MEMO: To All Bryston Customers

SUBJECT: Announcing Bryston Integrated Audio Device

May 2015

New Card

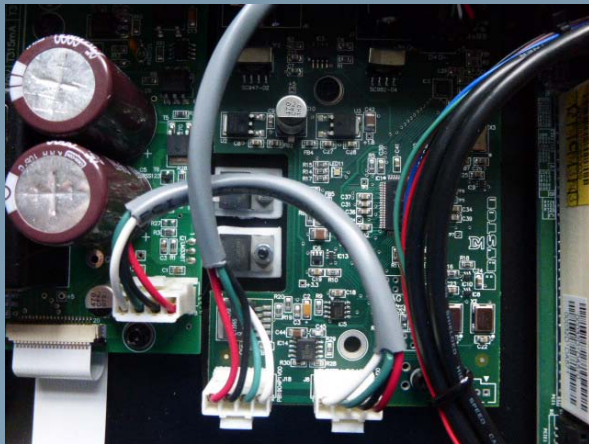
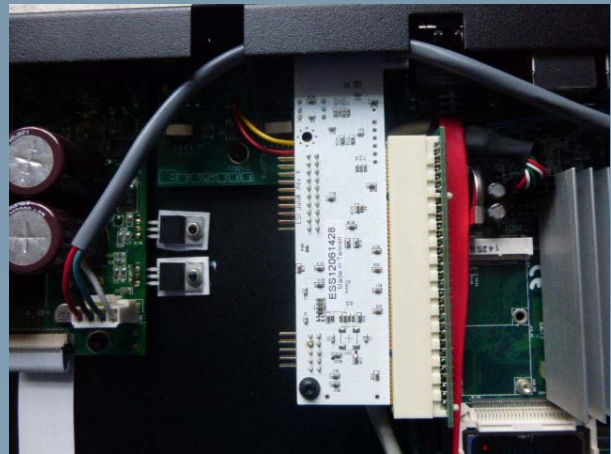
As I posted earlier we have been working on a Bryston proprietary “Integrated Audio Device” card to replace the current two-piece ‘Soundcard’ and ‘SPDIF interface module’ (AES/BNC) utilized in our current BDP-2 Digital Player.

- No reliance on the quality level of third party products or having to modify said products
- Improve the performance by hand selecting and testing all the components in house
- Eliminates 3 connection points
- Integrates the output module and the sound processing section into one circuit instead of two.
- The Bryston audio device is directly powered by the high quality linear power supply rather than the motherboard.
